SUBJECT: ISSUANCE OF AMENDMENTS - DONALD C. COOK NUCLEAR PLANT, UNITS 1 AND 2, RE: FUEL ROD ZIRLO CLADDING AND INTEGRAL FUEL BURNABLE ABSORBER REQUIREMENTS (TAC NOS. MA7041 AND MA7042)

Amendment No. 239  
License No. DPR-58

SAFETY EVALUATION BY THE OFFICE OF NUCLEAR REACTOR REGULATION  
RELATED TO AMENDMENT NO. 239 TO FACILITY OPERATING LICENSE NO. DPR-58  
AND AMENDMENT NO. 220 TO FACILITY OPERATING LICENSE NO. DPR-74

DONALD C. COOK NUCLEAR PLANT, UNITS 1 AND 2

Figure 5.6-4: New Fuel Storage Rack Integral Fuel Burnable Absorber (IFBA) Requirements

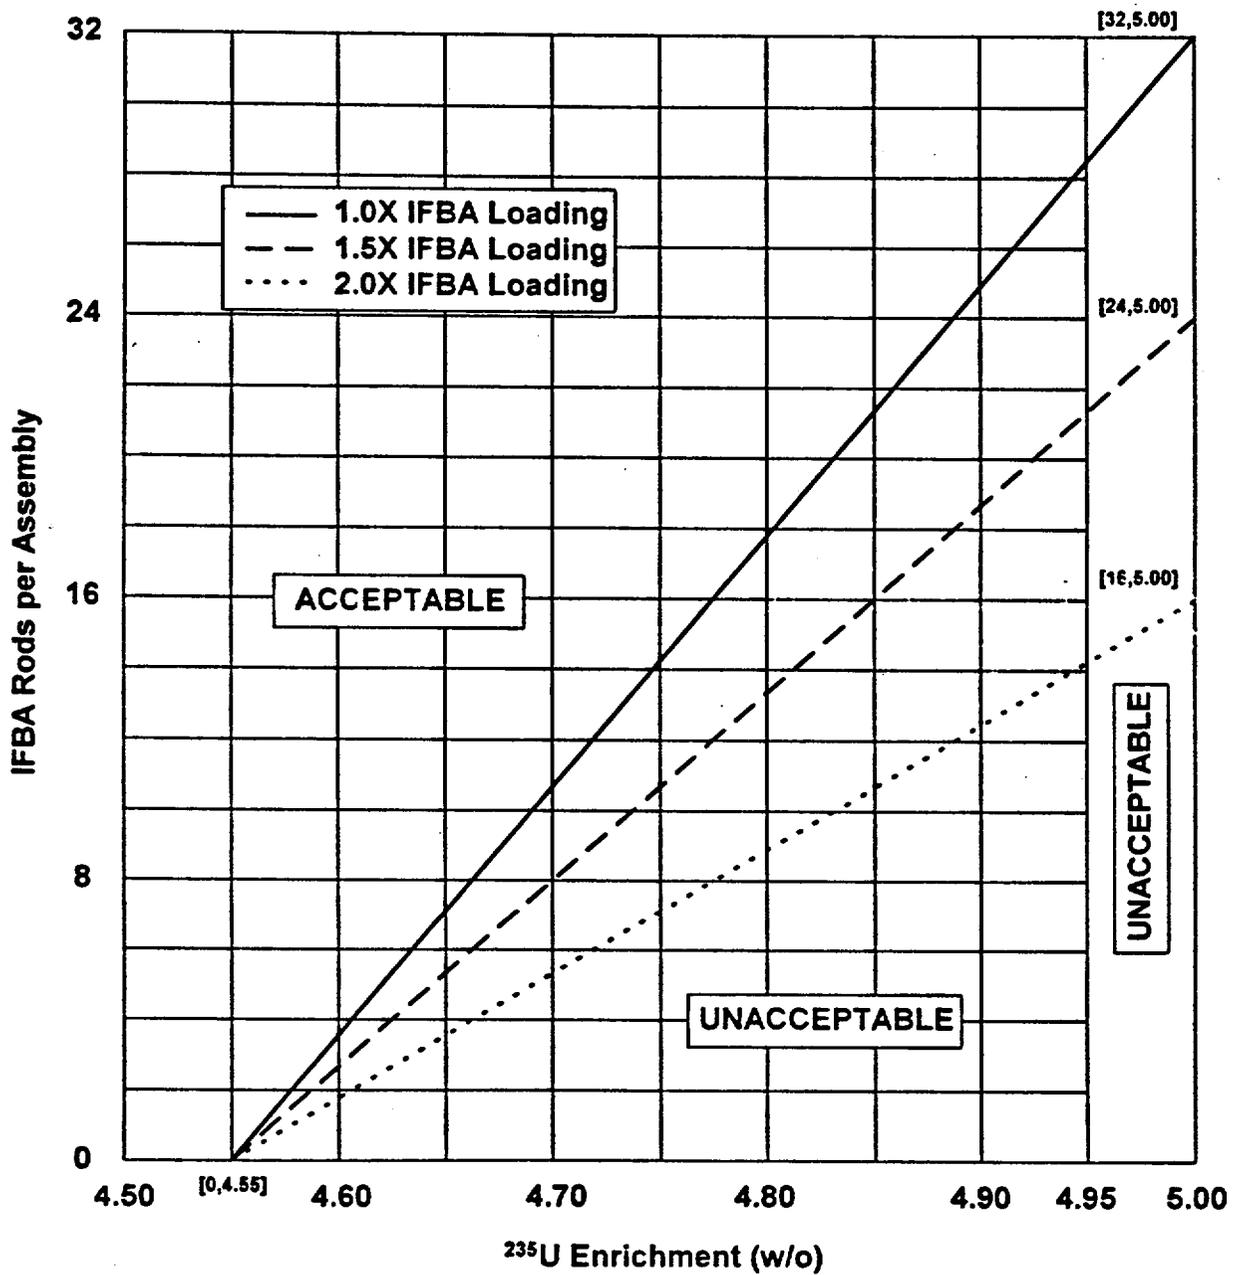
- a. Westinghouse fuel assemblies having either a maximum enrichment of 4.55 weight % U-235, or an enrichment between 4.55 and 4.95 weight % U-235 with greater than or equal to the minimum number of integral fuel burnable absorber pins as shown on Figure 5.6-4 (interpolation of the Boron-10 loading between 1.0X and 1.5X and between 1.5X and 2.0X is acceptable);
- b.  $k_{\text{eff}} \leq 0.95$  if fully flooded with unborated water, which includes an allowance for uncertainties as described in Section 9.7 of the UFSAR;
- c.  $k_{\text{eff}} \leq 0.98$  if moderated by aqueous foam, which includes an allowance for uncertainties as described in Section 9.7 of the UFSAR; and
- d. A nominal 21 inch center to center distance between fuel assemblies placed in the storage racks.

The licensee proposes to revise TS 5.6.2.a and add a new TS Figure 5.6-4, "New Fuel Storage Rack Integral Fuel Burnable Absorber (IFBA) Requirements," to specify maximum enrichments and IFBA requirements for Westinghouse fuel in the new fuel storage racks. Specifically, TS 5.6.2.a is proposed to state that the new fuel storage racks are designed and shall be maintained with "Westinghouse fuel assemblies having either a maximum enrichment of 4.55 weight % U-235, or an enrichment between 4.55 and 4.95 weight % U-235 with greater than or equal to the minimum number of integral fuel burnable absorber pins as shown on Figure 5.6-4 (interpolation of the Boron-10 loading between 1.0X and 1.5X and between 1.5X and 2.0X is acceptable)." The new TS Figure 5.6-4 specifically covers IFBA requirements between 4.55 and 4.95 weight % U-235. The licensee proposes to delete the footnote for TS Table 5.6-1 since it is superseded by the proposed change to TS 5.6.2.a.

New TS Figure 5.6-4 is based on the reactivity equivalencing calculational method described in CDB-95-175, which was previously reviewed and approved by the NRC for Amendment Nos. 213 and 198. Use of this method ensures the required reactivity margin is maintained for storage of Westinghouse fuel assemblies in the new fuel storage racks. Therefore, the staff considers the proposed method for determining IFBA requirements and resulting TS changes acceptable.

Figure 5.6-4: New Fuel Storage Rack Integral Fuel Burnable Absorber (IFBA) Requirements

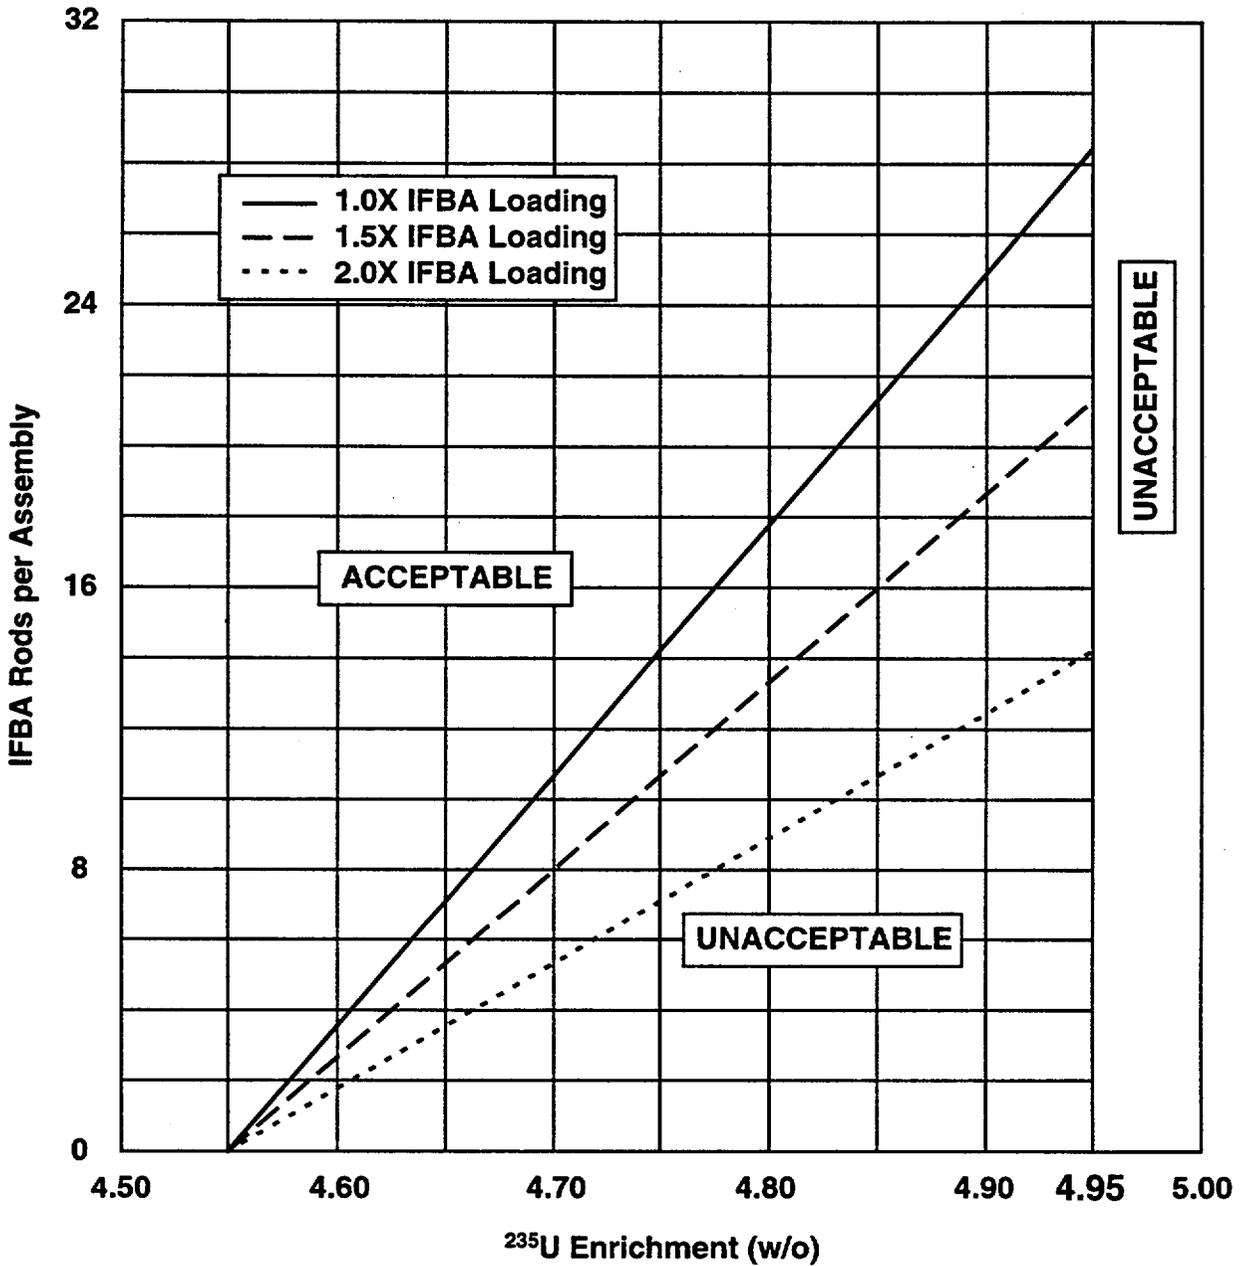
- a. Fuel assemblies having either a maximum enrichment of 4.55 weight % U-235, or an enrichment between 4.55 and 4.95 weight % U-235 with the minimum number of integral fuel burnable absorber pins as shown on Figure 5.6-4 (interpolation of the Boron-10 loading between 1.0X and 1.5X and between 1.5X and 2.0X is acceptable);
- b.  $k_{\text{eff}} \leq 0.95$  if fully flooded with unborated water, which includes an allowance for uncertainties as described in Section 9.7 of the UFSAR;
- c.  $k_{\text{eff}} \leq 0.98$  if moderated by aqueous foam, which includes an allowance for uncertainties as described in Section 9.7 of the UFSAR; and
- d. A nominal 21 inch center to center distance between fuel assemblies placed in the storage racks.
